23 December 2015

Parramatta Park & Western Sydney Parkland Trusts

**Re: Eastern Creek Business Hub, Rooty Hill Road South, NSW
SSD 5175 Mod 1
Blacktown Council Agency Response Letter**

TYPICAL CHANNEL 01 SECTION
SCALE 1:20

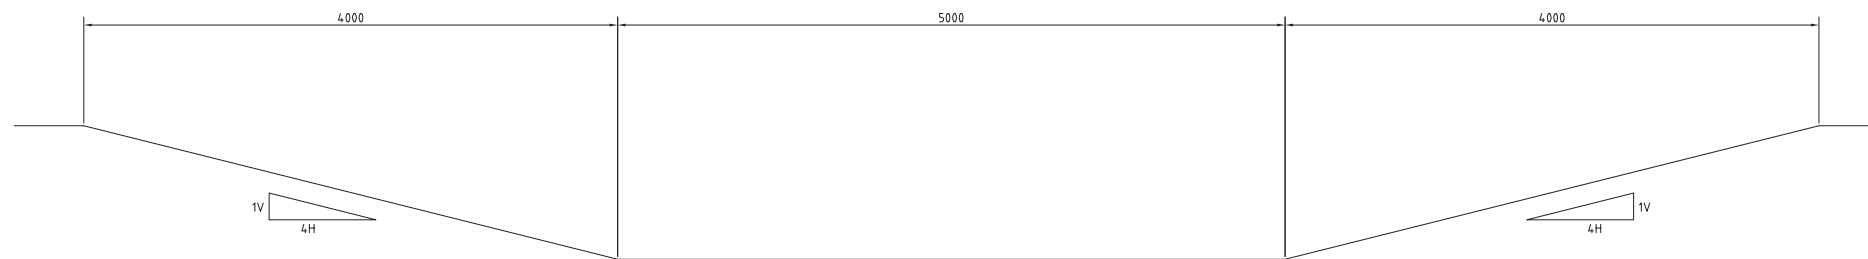
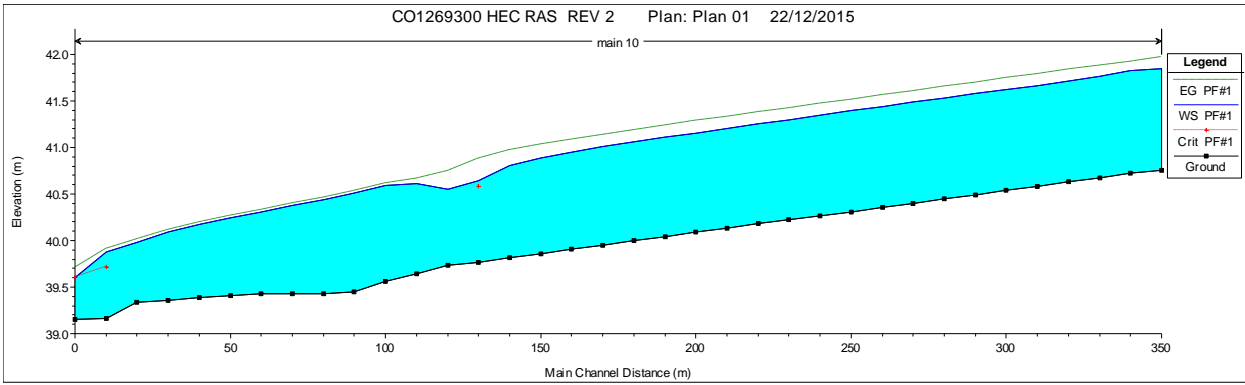
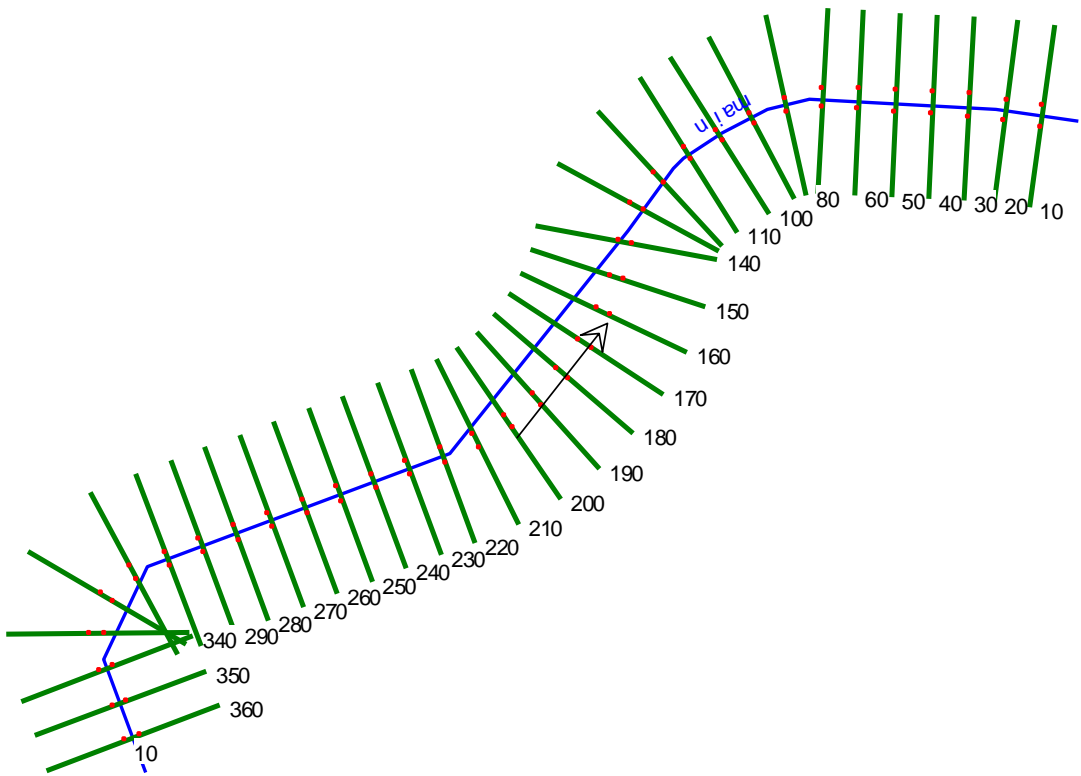
Following the meeting it has been confirmed that the proposed estate access road, associated infrastructure and overland flow path (Channel 01 as shown on drawing **Co12693.00-DA40**) will remain in the ownership of the Western Sydney Parklands Trust (WSPT). The adopted assessment parameters are based on this scenario and may differ from those requested by Council in their letter of 26 October 2015. The outcome and planning requirements remain consistent with council requirements and any differences between adopted parameters and this requested by Council are discussed in the following sections.

A 1D HEC-RAS model of the open channel has been completed to confirm the suitability of the proposed channel cross section to convey the $12.9\text{m}^3/\text{s}$ design flow. The HEC-RAS assessment is based on the following parameters:

- Design ARI = 1 in 100 year (1% AEP)
- Channel 01 Roughness (base), Manning's $n = 0.04$;
- Channel 01 Roughness (banks), Manning's $n = 0.04$;
- Extg. Creek Roughness Manning's $n = 0.1$ (base), 0.07 (banks);
- Channel bank maximum slope = 1 vertical to 3 horizontal;
- Upstream Boundary Condition: Normal, $s = 0.01$;
- Downstream Boundary Condition: Known Water Surface Level = RL 39.0m AHD (Basin 1 Q100 ARI W.S.L.); and
- Subcritical, steady flow analysis.

As noted earlier in this letter, some of the parameters differ between Councils letter and those adopted. The Manning's roughness of 0.04 has been adopted which is consistent with the original SSD application however lower than the requested by Council of 0.1 for the channel base and 0.07 for the channel banks. The adopted parameters are consistent with a formed open channel with grassed base and sides. The values requested by Council are consistent with a formed channel with heavily vegetated base and banks with thick reedy vegetation and heavy brush. We understand that Council requested the use of these values as their maintenance regime, if ownership of the channel were to be handed to Council, was lacking and there would be potential issues with channel capacity in the long term. Given Channel 01 will be owned and maintained by WSPT, who have a strict Stormwater Maintenance Schedule, the lower roughness values for a grassed channel are considered appropriate. The banks of Channel 01 also remain at 1v : 1h in geometry which is also consistent with the channel remaining an asset of WSPT. This arrangement has been discussed with council through Mr George Henien of WSPT during the week beginning 21 December 2015. Roughness parameters for the existing creek, between Channel 01 and the detention basin have been modelled with the council roughness parameters which are consistent with the condition of the existing creek bed.

- The 1 in 100 year design flow of $12.9\text{m}^3/\text{s}$ can be contained in the proposed Channel 01 cross section;
- The 1 in 100 year water surface level, at the upstream end of Pad 1 (adjacent to Rooty Hill Road) is RL 41.85m AHD. The corresponding flood planning level for Pad 1, allowing for 500mm freeboard, is RL 42.35m. We confirm the proposed earthworks level for Pad 1 is RL 43.0m which provides for greater than 1150mm of freeboard to the calculated overland flow water surface level;
- Flow depths in the channel are typically in the order of 1000mm; and
- Velocities typically are consistent at 1.8m/s. Corresponding depth-velocity values of 1.8 will be experienced which are greater than those recommended for pedestrians during a flow event. As such the channel will be required to be fenced to achieve safety requirements for the channel.

ENCLOSURE 2
FLOOD EXTENT SKETCH

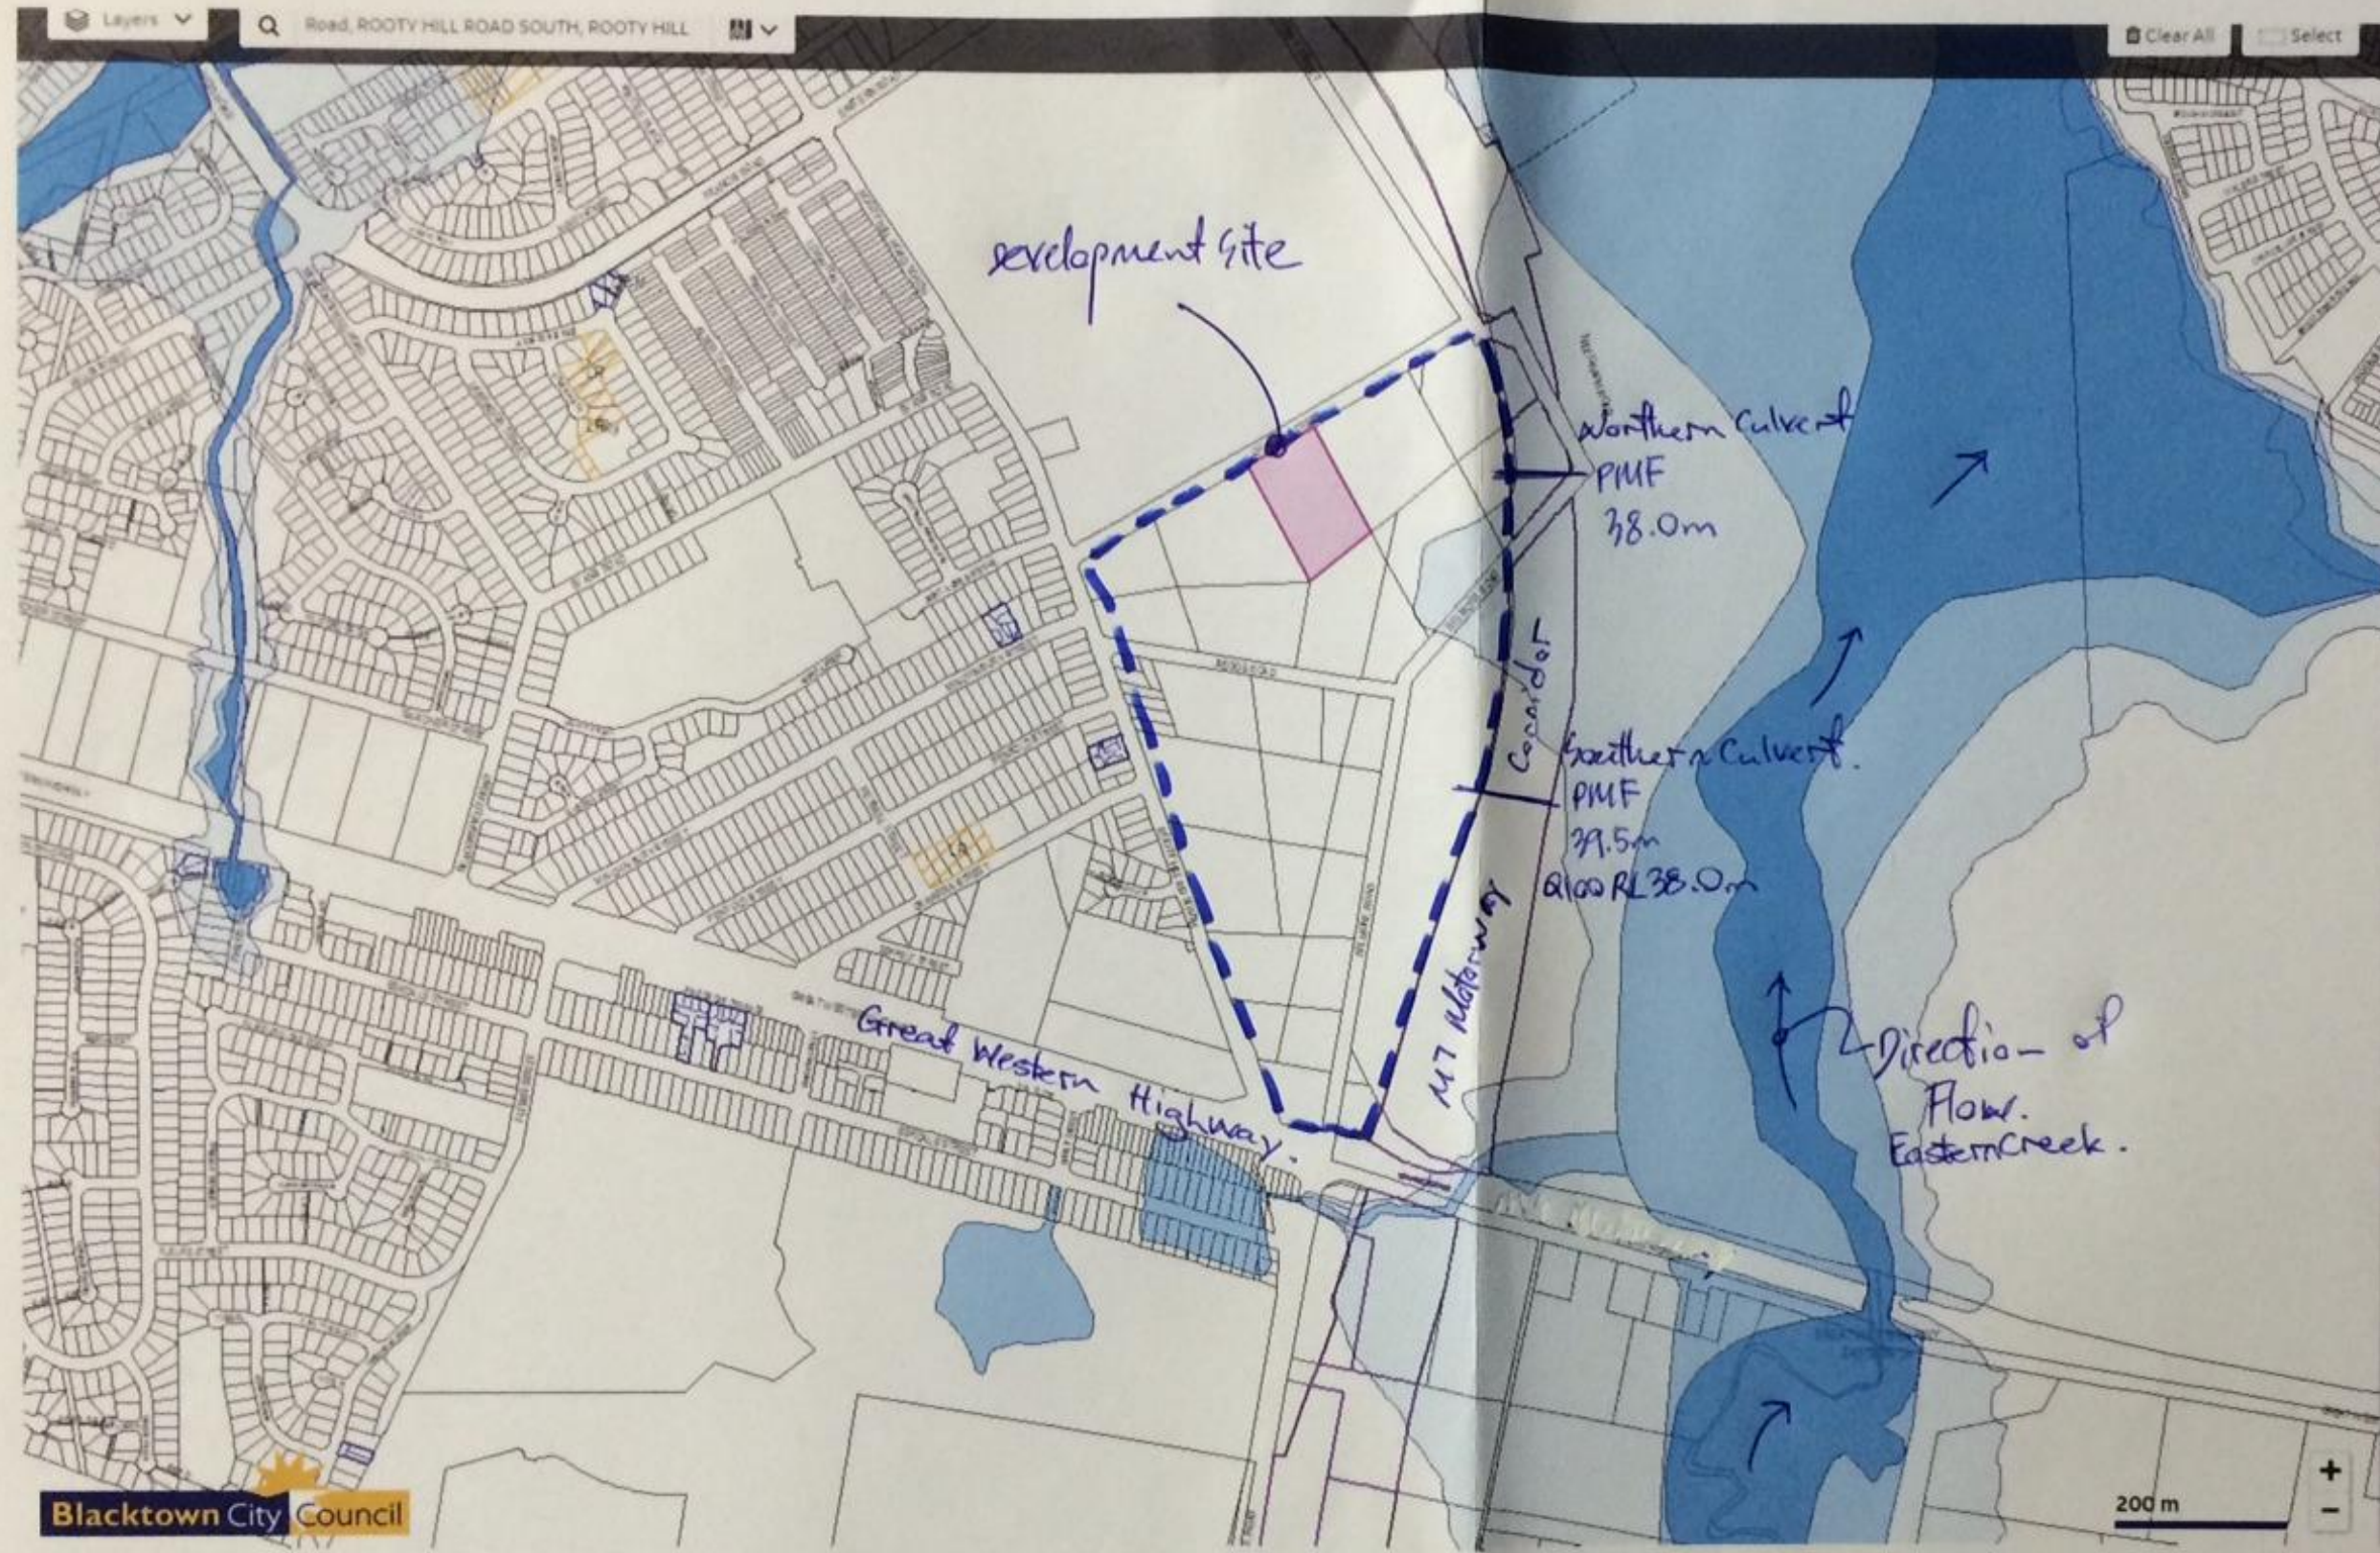
Council has raised concerns regarding the flood impact from local overland flow and from regional flooding relating to Eastern Creek. The HEC-RAS analysis provided above confirms the local overland flow is able to be conveyed through the site and flood immunity to the building pads is able to be achieved.

Eastern Creek is located downstream of the site some 250-300m to the east of the M7 Motorway. Flood studies undertaken by J. Wyndam Prince, as quoted in Section 6.6 of their Eastern Creek Business Hub Water Cycle Management Strategy Report (included in the original application submission), nominate the 1 in 100 year ARI flood level of Eastern Creek at RL 38.0m AHD. The Section 7.2 of this report also nominates the PMF flood level at RL 39.5m at the southern culvert and RL 38.0m at the northern culvert. The flood extent is consistent with Blacktown Councils on-line interactive flood mapping tool and can be seen to be clear of the site and stormwater management measures on the site.

The flood levels and extent have been marked on a print out of Councils on-line flood mapping tool for visual confirmation of the above. This sketch has been provided as **Enclosure 2** of this letter.

Further we confirm the minimum proposed pad level of RL 42m AHD is 4m higher than the predicted 1 in 100 year ARI flood level. Also the minimum level of the estate access road is RL 40.3m AHD, 2.3m above the predicted 1 in 100 year ARI flood level.
